ALERT SERVICE BULLETIN

429-21-54

MODEL AFFECTED: 429

SUBJECT: MAIN ROTOR TRANSMISSION DEBRIS PAN ASSEMBLY 429-040-407-101, ONE TIME INSPECTION OF.

Figure 1 – Borescope Inspection Of The Debris Pan Assembly

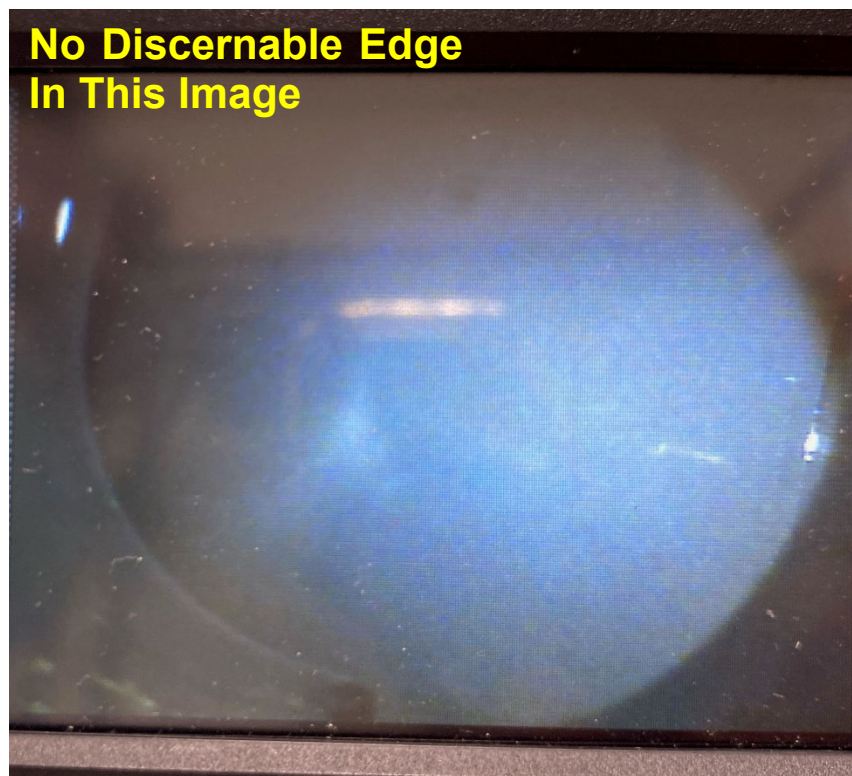
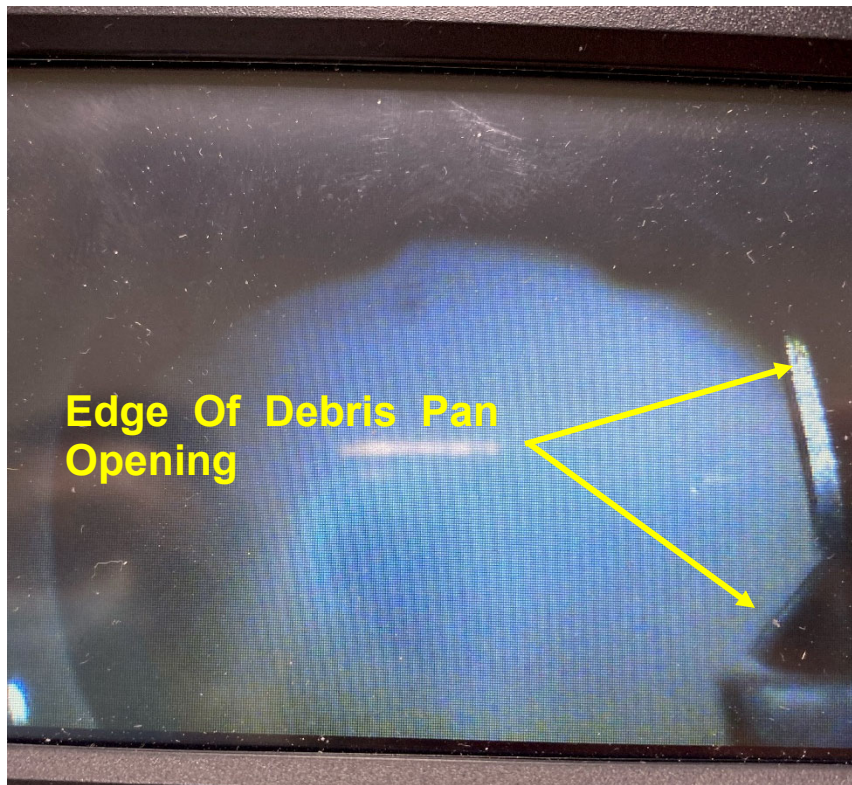
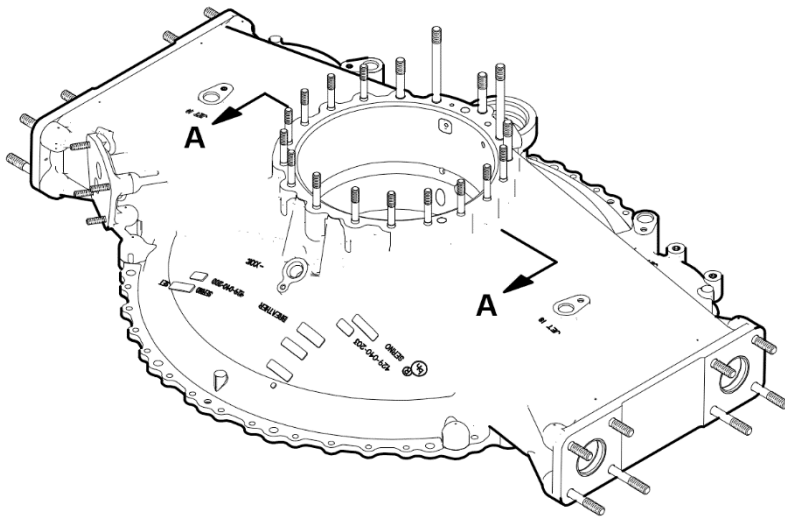
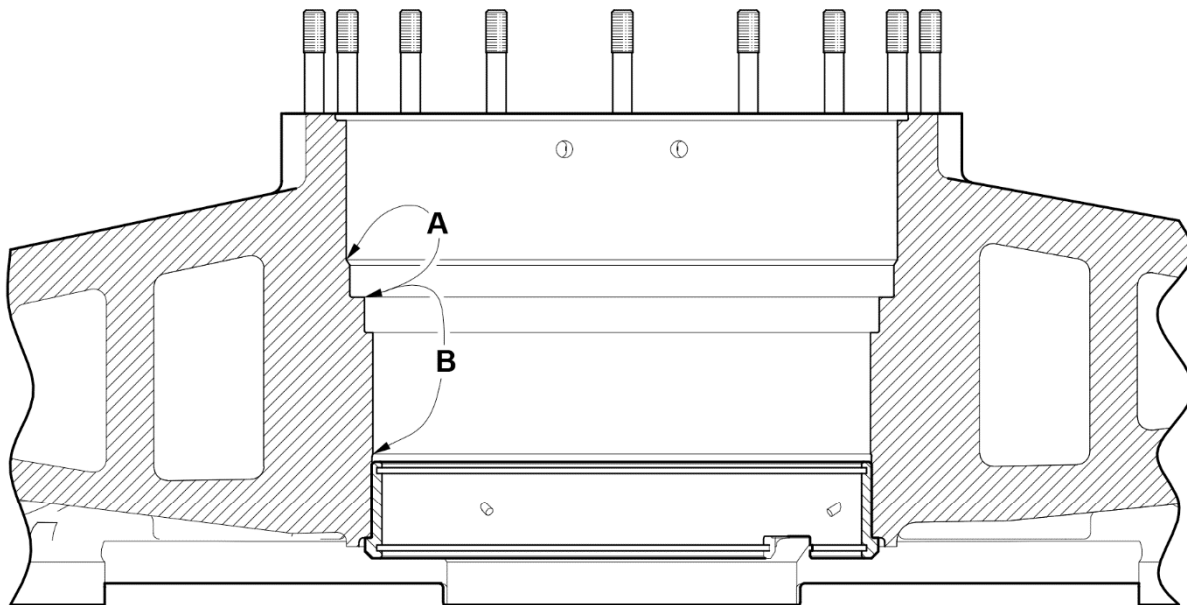
4. Remove mast chip detector (DMC-429-A-63-20-00-16A-520A-A).
5. Using a borescope, inspect the debris pan assembly (1, Figure 1) for the presence of the opening for the lubricating oil as shown in Figure 1.

- a. If the edge of the debris pan opening is visible proceed to step 14.
 - b. If the edge of the debris pan opening is not visible, proceed to next step.

Figure 2 – Debris Pan Seat Damage Limits

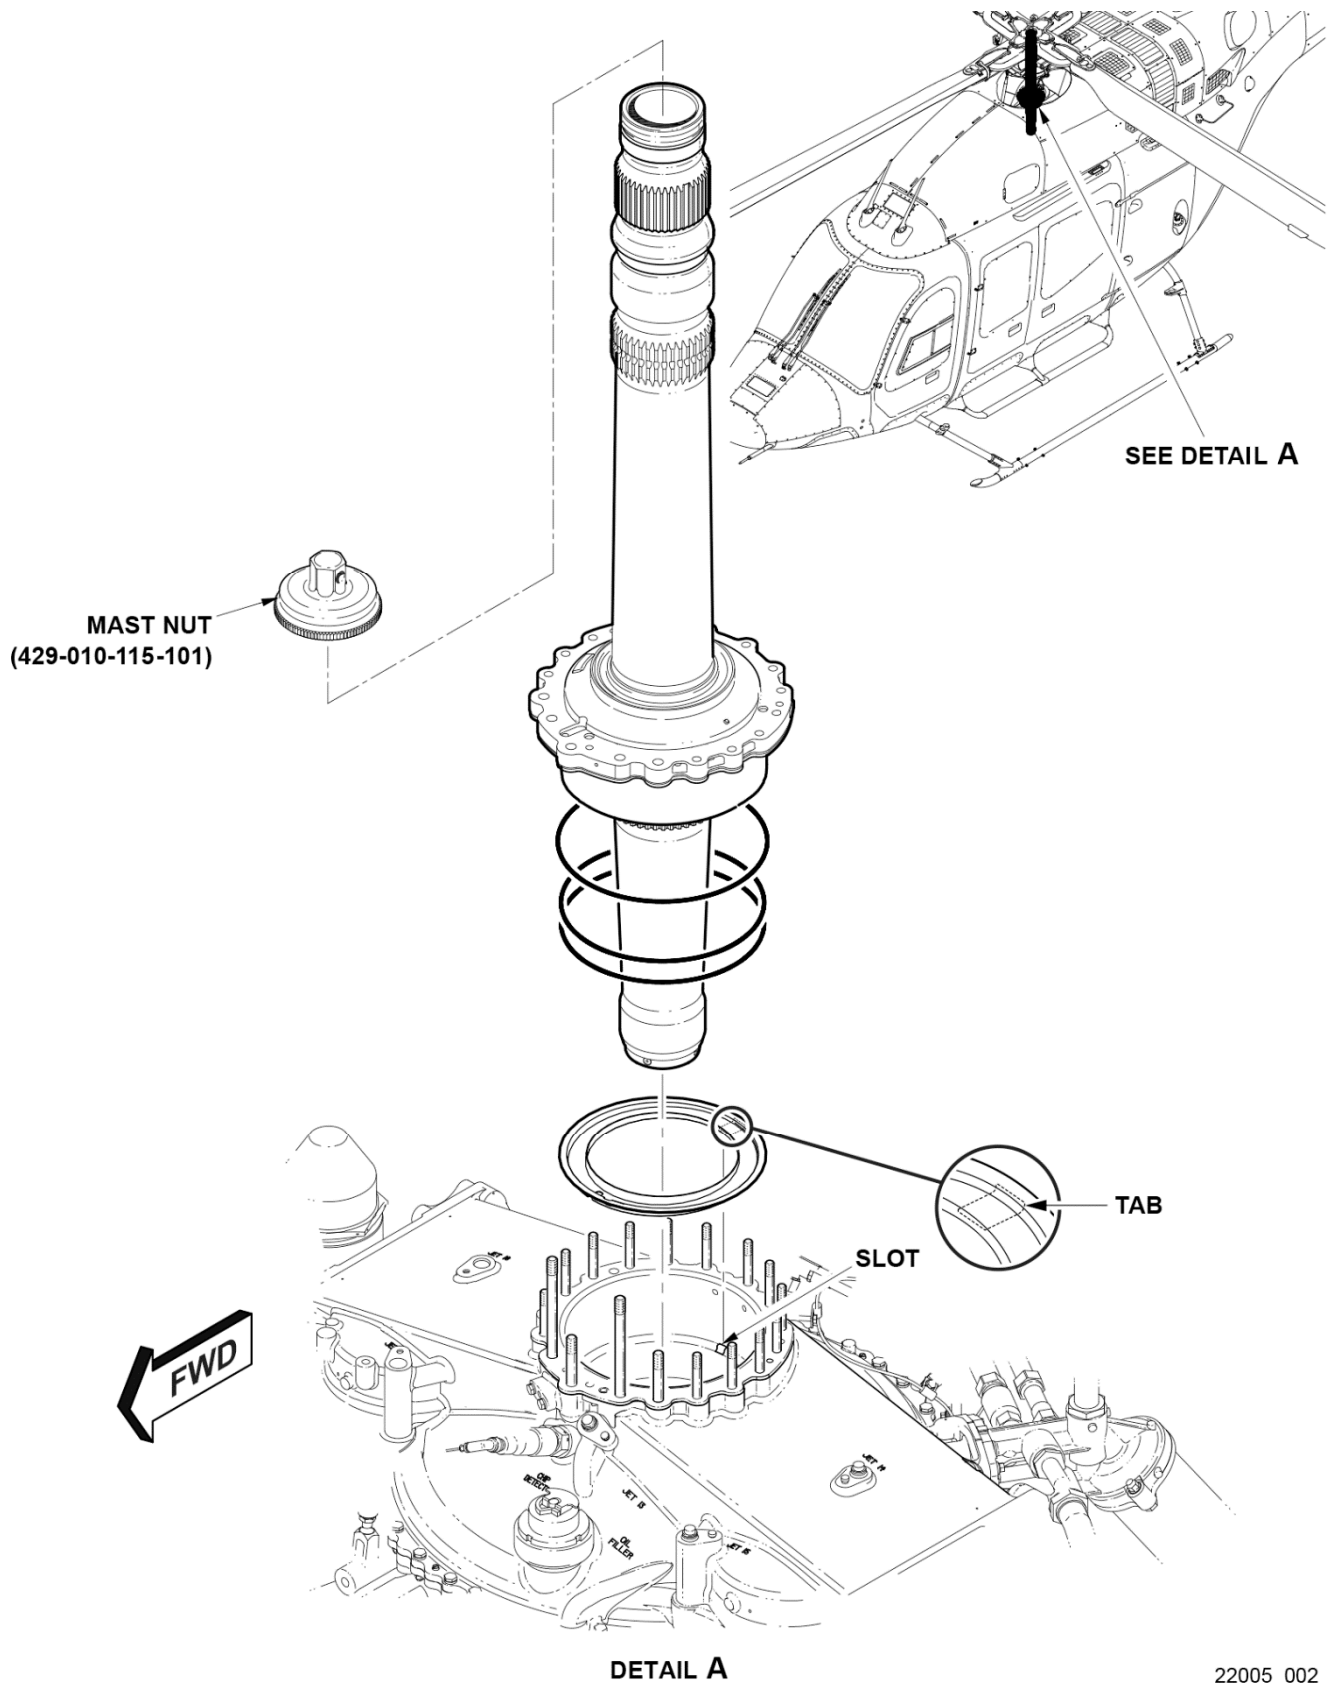
11. Inspect the visible internal portions of the transmission assembly for the presence of metal contamination and mechanical damage to the debris pan seat (Figure 2).

- a. Repair mechanical damage with stainless steel wool (C-171) abrasive pad (C-407) or India stone (C-464), as applicable, in accordance with the instructions in the BHT-ALL-SPM, Chapter 3. The surface finish after repair must be 32 Roughness Height Rating (RHR) with a minimum radius of 0.100 inch (2.54 mm), unless otherwise specified.

NO.	REF LTR	CHARACTERISTIC	INSPECTION METHOD	LIMIT
1.	A	Mechanical/corrosion damage	Visual	None permitted.
2.	B	Mechanical/corrosion damage	Visual/measure	0.010 inch (0.25 mm) maximum depth and no more than 10% of total area of surface or diameter.
